MANPRINT ASSESSMENT OF THE
HIGH MOBILITY MULTIPURPOSE WHEELED VEHICLE
HEAVY VARIANT (HMMWV-HV)
(Contract MDA903-83-C-0033)

March 1988

HIGH MOBILITY MULTIPURPOSE WHEELED VEHICLE HEAVY VARIANT (HMMWV-HV)

Figure 3.3.2. Litter loading and unloading ramp.

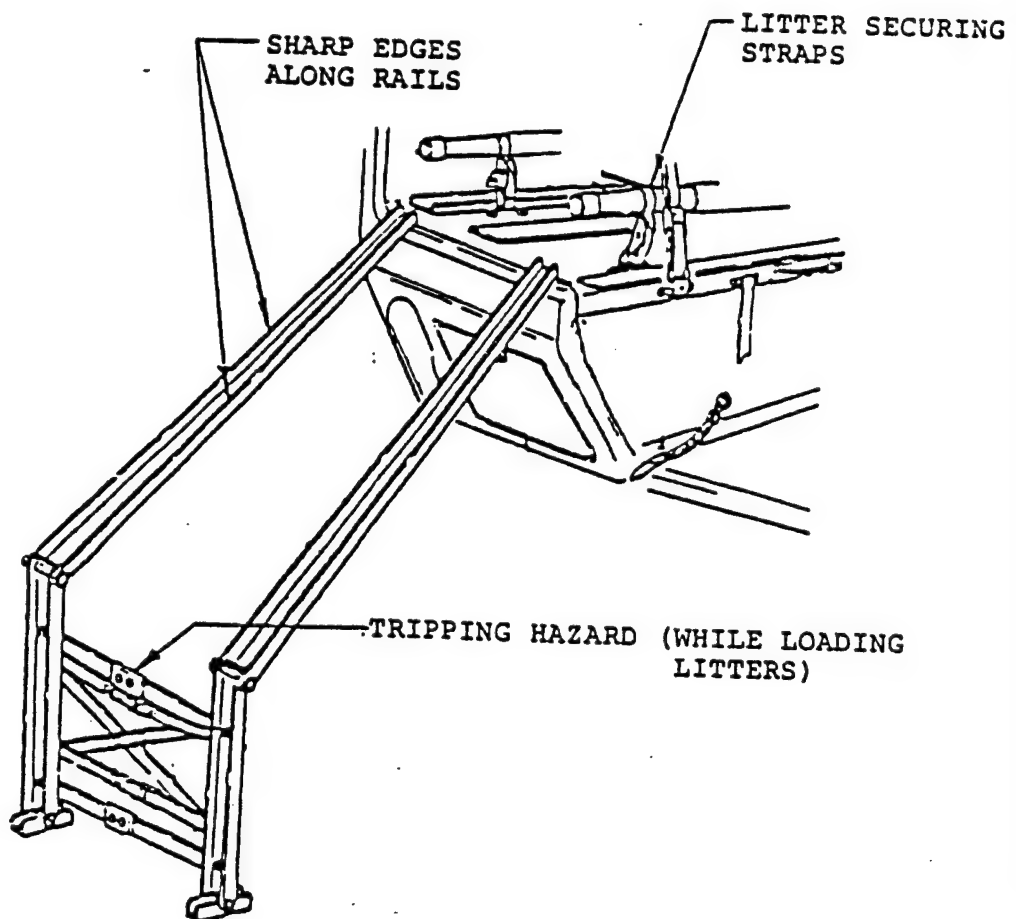
- a. The litter bearers' effectiveness to load and unload litters is decreased by (see Figure 3.3.2):
 - 1) Sharp edges exist along the length of the litter ramp rails.

c. Difficulty securing upper litter patients while loading in the maxi-ambulance slows the patient loading process.

a. Litter ramp rail edges should be rolled. The litter ramp attachment to vehicle lugs should be altered to increase their ability to stay secured. Loading procedures should be revised to have litter bearers load litters using a side-carry loading method. This method would avoid the litter ramp structure tripping hazard and would also allow for both litter bearers to apply the lifting and pushing forces required to load the litter.

b. Incorporate a litter-securing device that first clamps to the litter. Second, litter securing tension is applied.

Figure 3.3.3. Rear view side mirror.

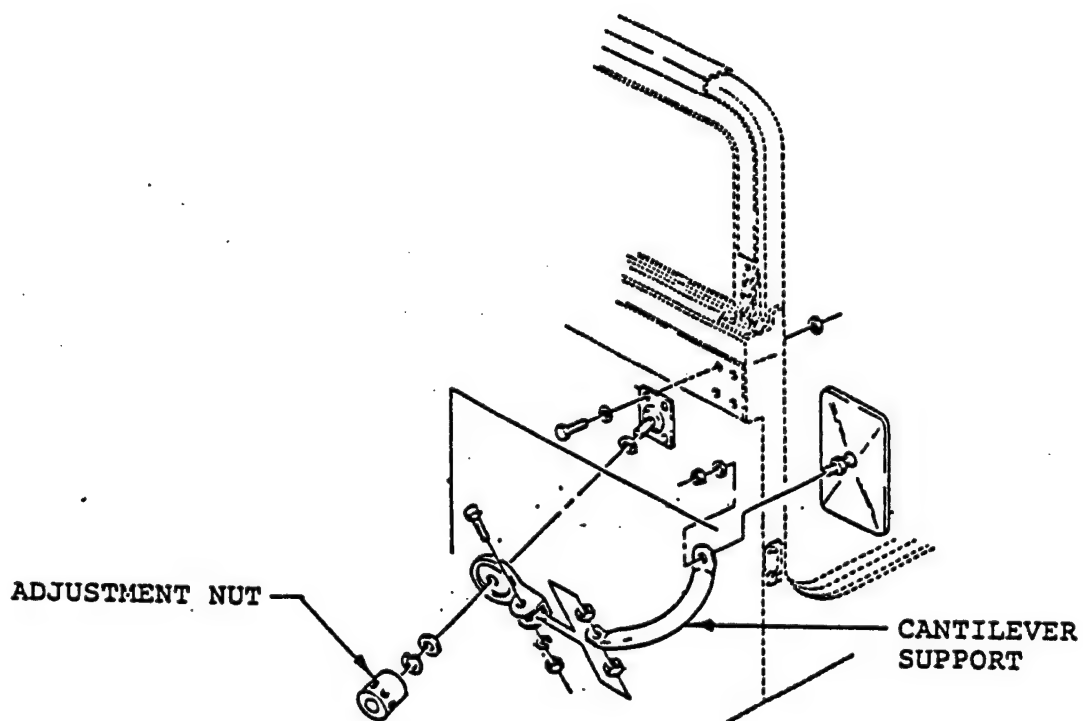
The side mirrors on the HMMWV ambulances and shelter carrier are too small and vibrate excessively. The hardware for mirror adjustment to the window frame mount vibrates loose, and the mirror falls to the side of the vehicle due to the length of the support. Operators claim the passenger side mirror is poorly positioned and does not provide a view. Shelter carrier drivers complain they do not have adequate rearward view to monitor their trailer status.

The mirror is supported by a single support that is approximately 20 inches (50 cm) long and is cantilevered from the mounting and adjusting hardware (see Figure 3.3.3). Vibration acting on the same plane as the adjustment nut tends to loosen the nut.

Excessive vibration blurs operator's rearward view. Loose hardware disables the use of the mirror. The small size of mirrors, approximately 5 by 7 inches (12.5 by 17.5 cm), limits effectiveness.

a. Increase support of the mirror by adding an extra support member in a triangular configuration.

DESCRIPTION
Figure 3.3.6. Pioneer tool rack attachment.

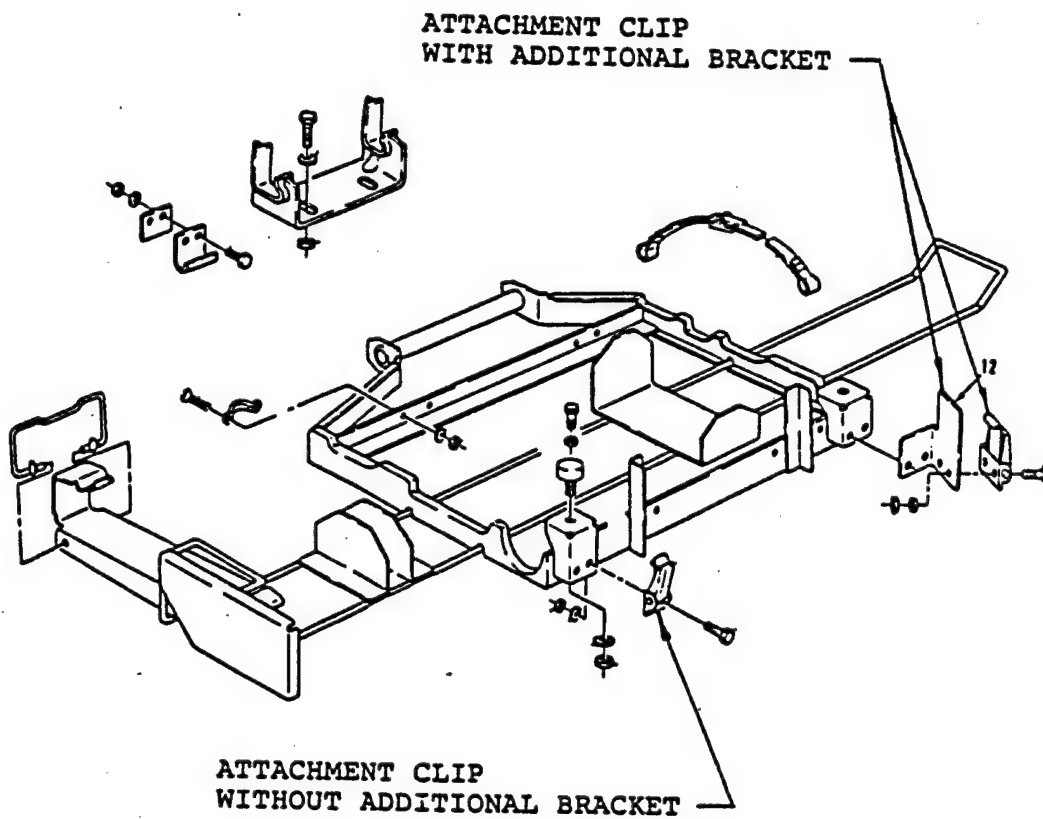
The standard pioneer tool racks that fit the HMMWV cargo or tow will not fit the HMMWV-HV ambulances or shelter carrier. Racks furnished for the ambulances or shelter carrier come with a special angle bracket to adapt the pioneer tool rack to these vehicles (see Figure 3.3.6). One ambulance (B02) was issued a standard pioneer tool rack (including tools) which would not fit beneath the ambulance. These tools were stowed inside the ambulance compartment, interfering with personnel movement inside the compartment.

Pioneer tool sets will not attach universally to all HMMWV vehicles. Situations as described above will occur.

DESCRIPTION
Figure 3.4.1. Shelter mounting kit.

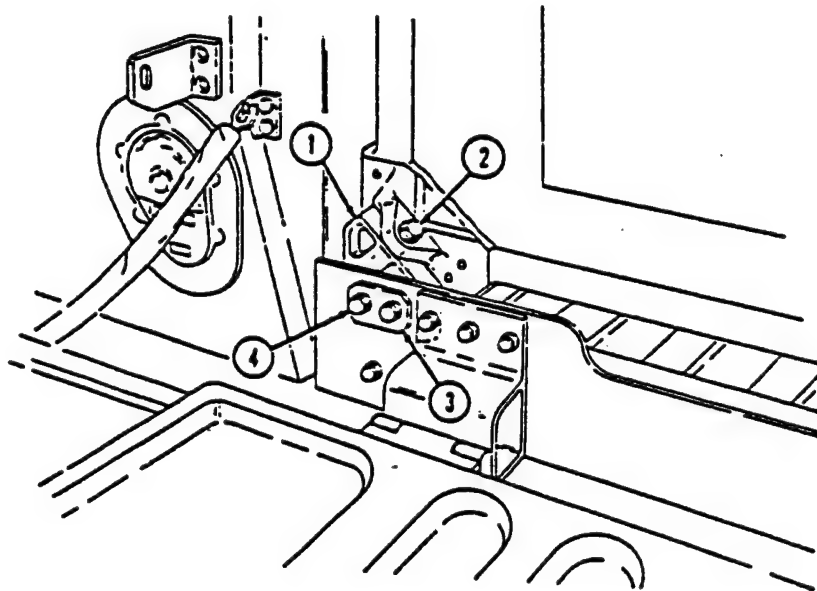
b. The mounting kit bolts (Figure 3.4.1, Items 2 and 4) behind the cab and passenger seat are difficult to align and start.

a. Some of the S-250 shelters will not fit to HMMWV-HVs with the mounts provided by the manufacturer.

b. Crewmen claim it takes up to three times the amount of time to align and start these bolts.

a. Design the shelter mount to accommodate both versions of the S-250 shelter.

b. Instruct personnel to remove passenger seat when installing the shelter on the HMMWV-HV.

Figure 3.4.2. Oxygen bottle racks.

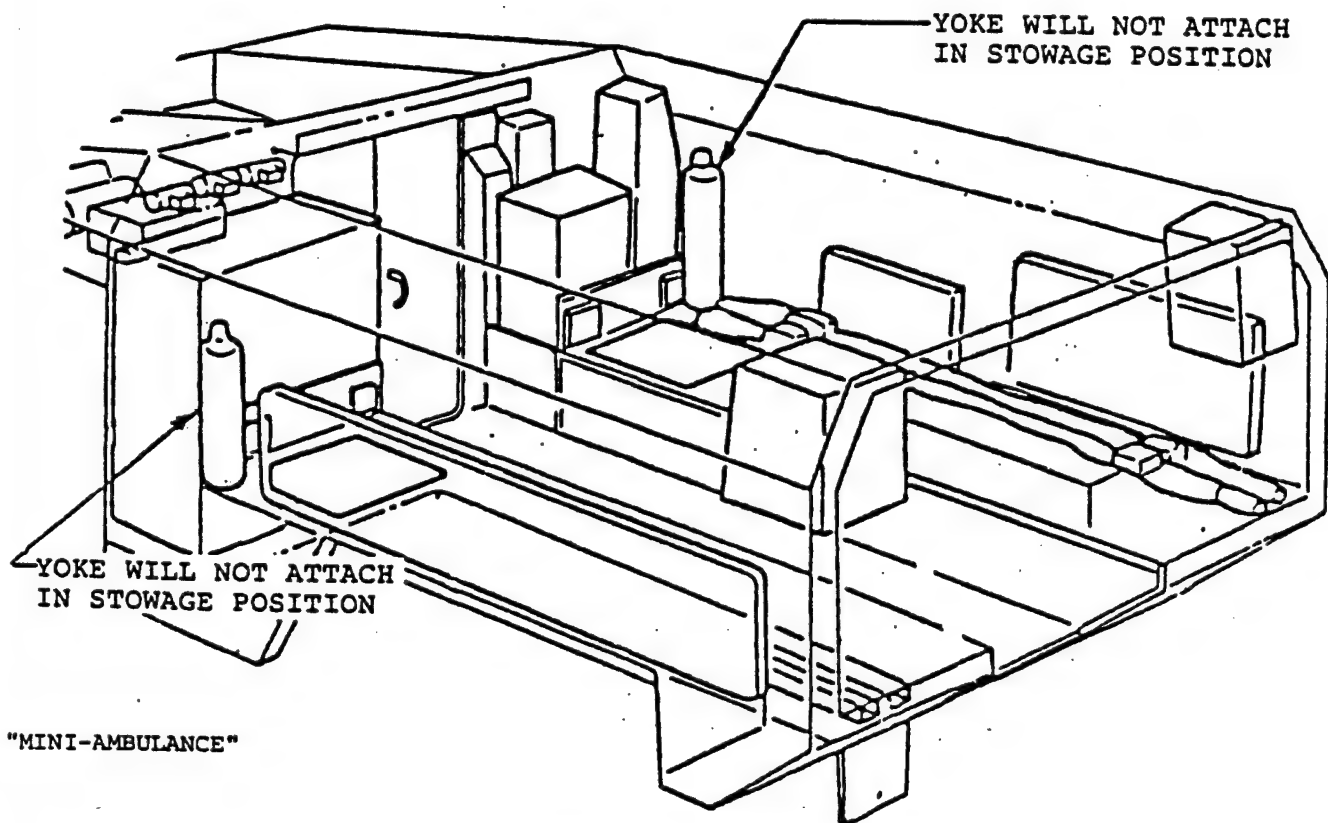
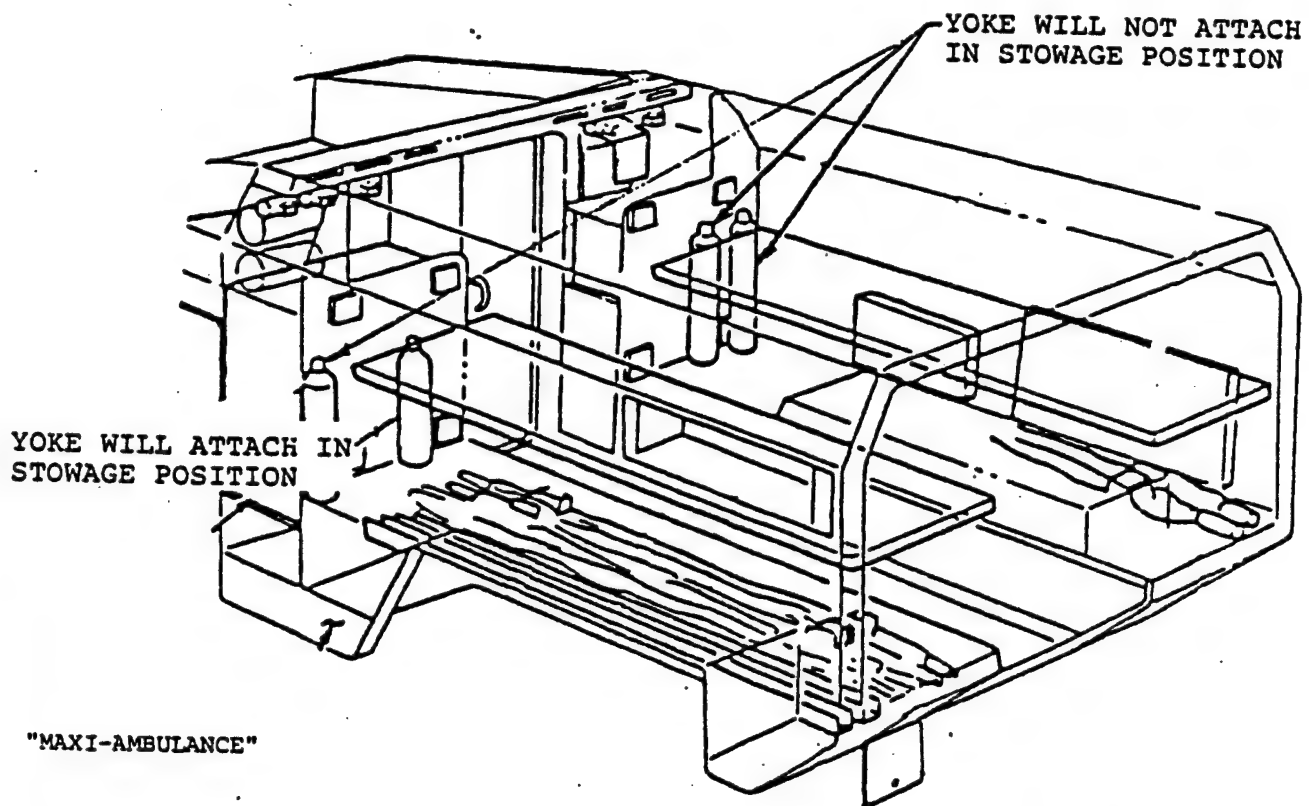
The oxygen bottle rack mounts position the bottles without enough room to allow for the attachment of the yoke adapters. Bottles cannot be put into service in stowed position at present. Only one rack position in the maxi-ambulance (see Figure 3.4.2) will allow the O₂ bottle to be made ready (with the yoke attached) for operation while in the stowage rack. There are no provisions to secure oxygen bottles to litters if the oxygen bottles are placed next to patients on litters.

Oxygen bottles are not usable unless they are removed from rack and cannot be stowed until after yokes are removed. Bottles that are not secured during use or layed on the patient's litter may be thrown about a moving vehicle and cause injury to aidmen or patients.
